Re: Florida Power & Light Company North Florida Resiliency Connection Permit No's. 12-0378587-001, 010; Request for Minor Modification

Attachment A—NFRC HDD Crossings Exhibit

DESCRIPTION NORTH FLORIDA RESILIENCY CONNECTION

FLORIDA POWER & LIGHT COMPANY	JOB NUMBER	R
IORTH FLORIDA RESILIENCY CONNECTION	165700	_
PERRY HDD CROSSING 11 PLAN AND PROFILE	P1-4	IBE

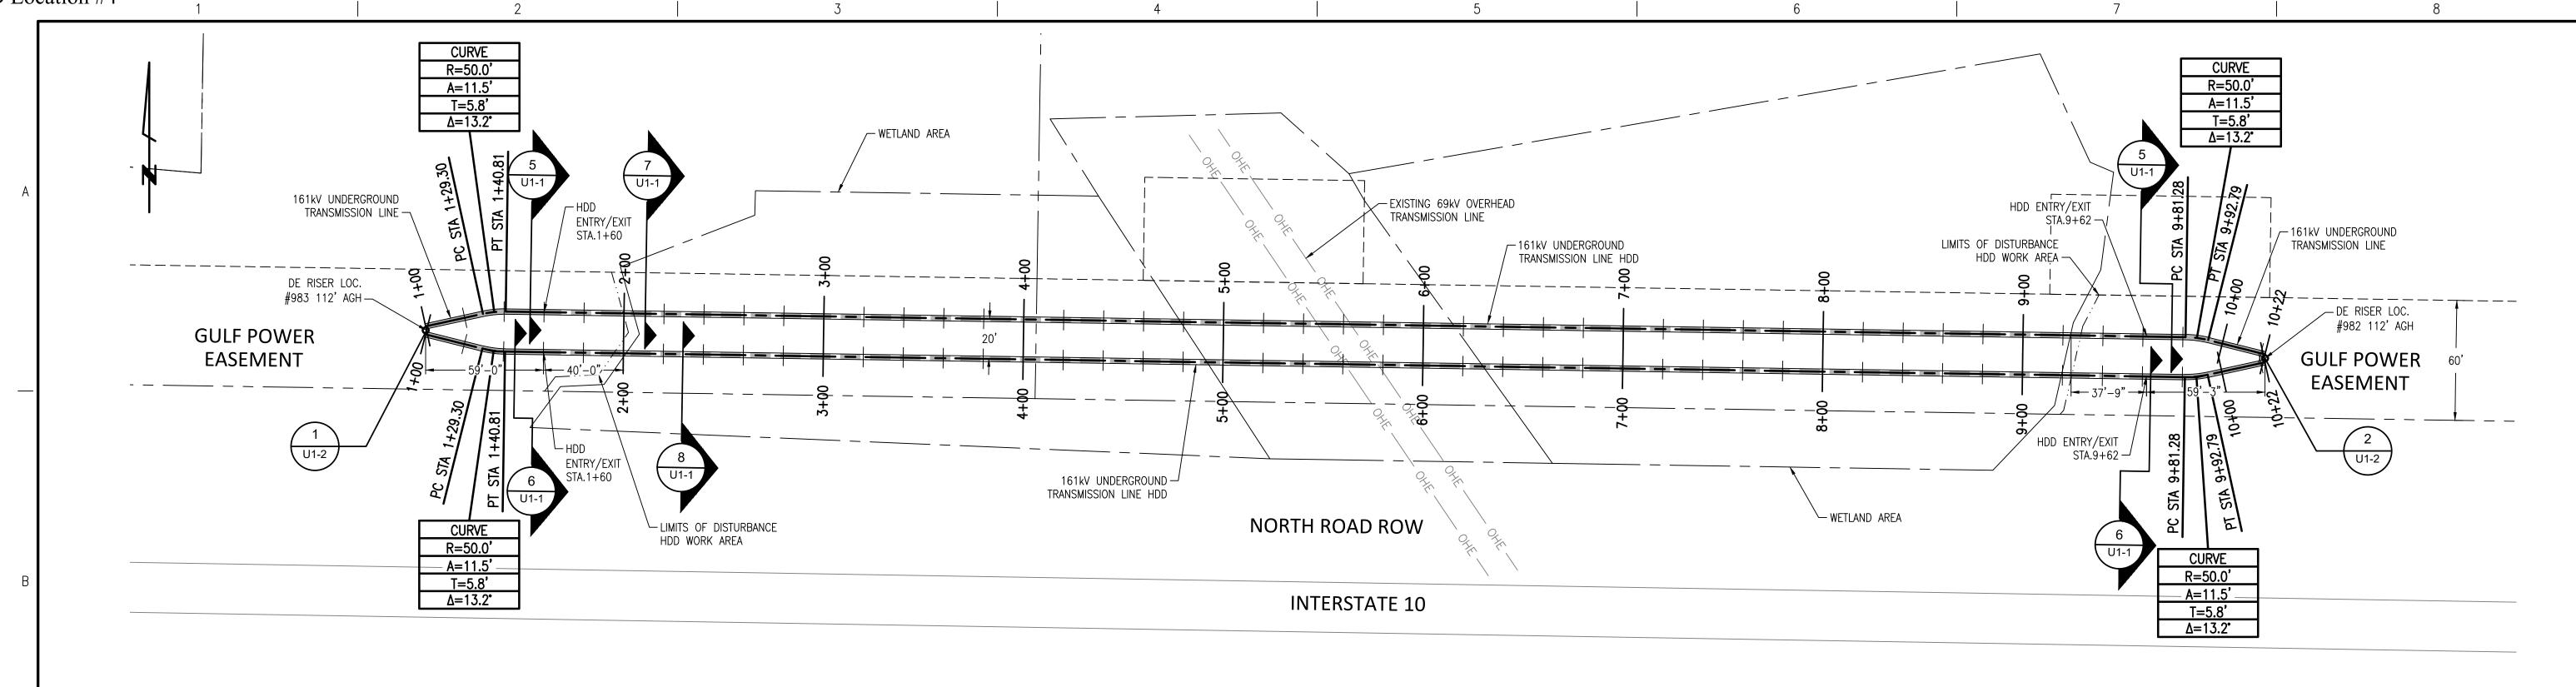
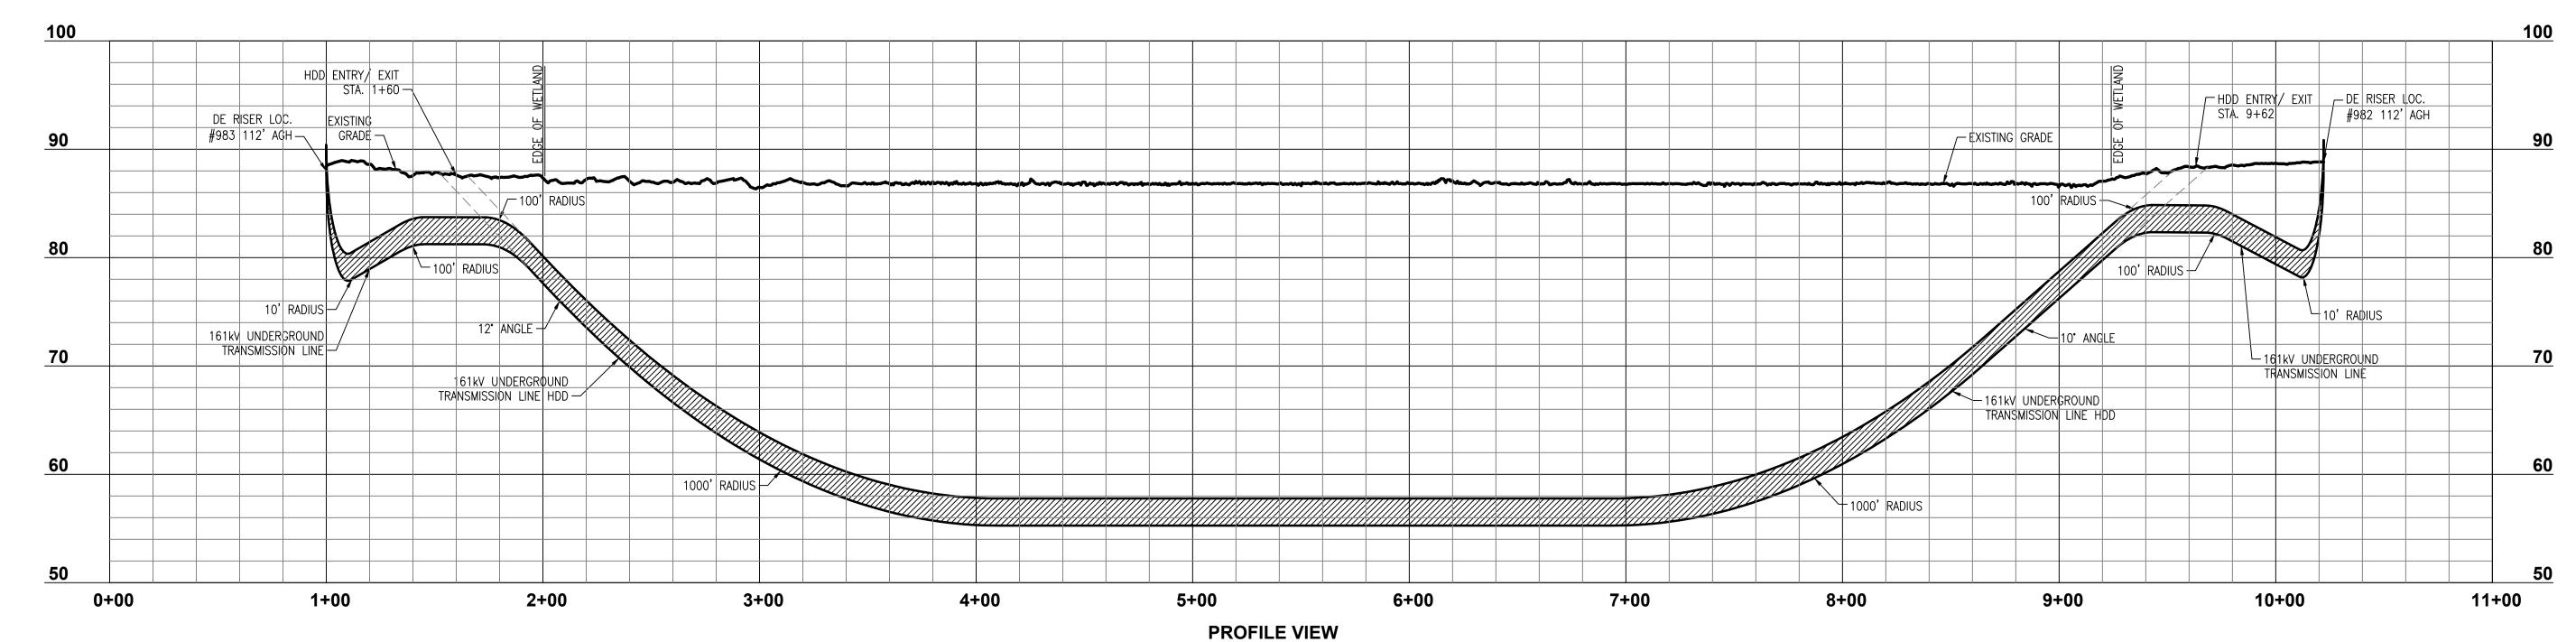
Attachment A contains the proposed four HDD locations, including construction details for the one location beneath wetlands. Attachment B is a map of the HDD location beneath wetlands and depicts the reduced wetland impacts both in illustration and table format. Attachment C provides the detailed inadvertent release plan for the HDD activities.

The updated project design and construction method, as depicted in Attachments A and B, results in a 0.82-acre reduction of permitted wetland impacts associated with the project. The change in impacts associated with the proposed refinements consist of the reduction of temporary construction impacts to 0.03 acres of forested wetland and 0.13 acres of non-forested wetland as well as the avoidance of 0.53 acres of permanent conversion of forested to non-forested wetland and the reduction of 0.13 acres of permanently maintained non-forested wetland.
